New Reactors Division

Step 4 Assessment of Structural Integrity for the UK Advanced Boiling Water Reactor

Assessment Report: ONR-NR-AR-17-037
Revision 0
December 2017

Figure 5: MS Piping Weld Locations Schematic (Reference 79)

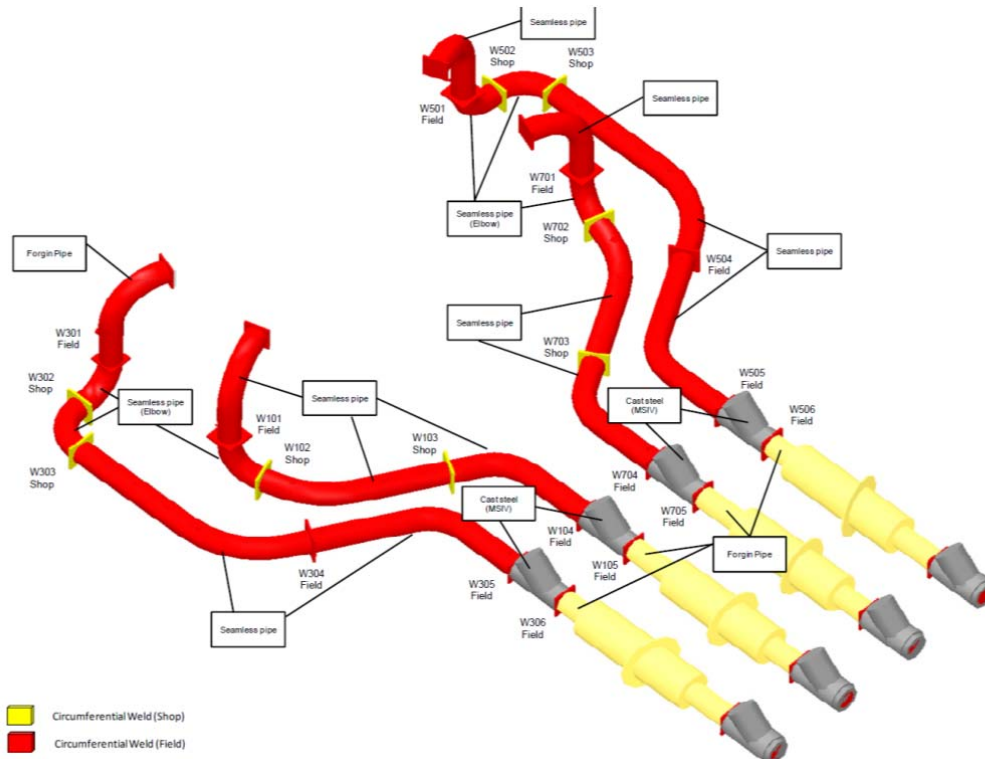
- RPV Bottom Head Welds; low combined scores Welds 8 and 9 Figure 2, (Reference 109)
 - RPV Bottom Head Welds (Welds 8 and 9 Figure 2, (Reference 110)
 - Main Steam Piping to inboard MSIV weld; low DTA and combined scores Weld W305, (Reference 111)

Figure 6 – Description of the RWCU for the UK ABWR

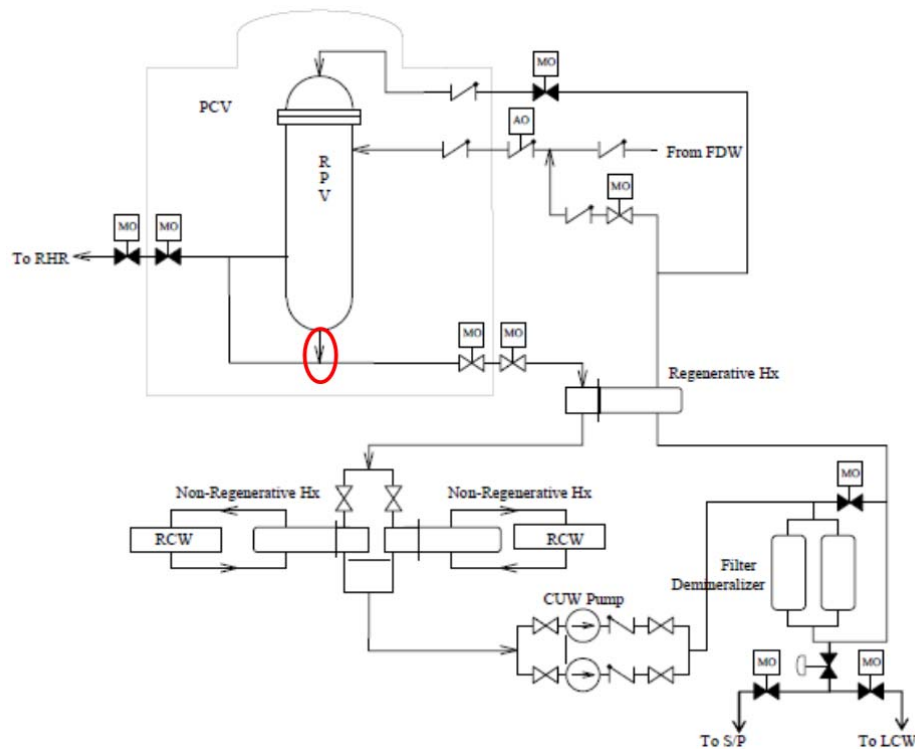
620. RO-ABWR-0034 is entitled "Demonstrating the inclusion of a 'bottom drain line' in the UK ABWR design achieves inherent safety and reduces risks SFAIRP", and was raised by the Reactor Chemistry discipline. It does, however, contain strong links to the Structural Integrity discipline; hence it has been included in this report.
621. The UK ABWR includes a design feature referred to as the 'bottom drain line' (BDL). The line is located at the bottom of the RPV and is included in the Reactor Water Clean Up (RWCU), the 'bottom drain line' is highlighted in Figure .
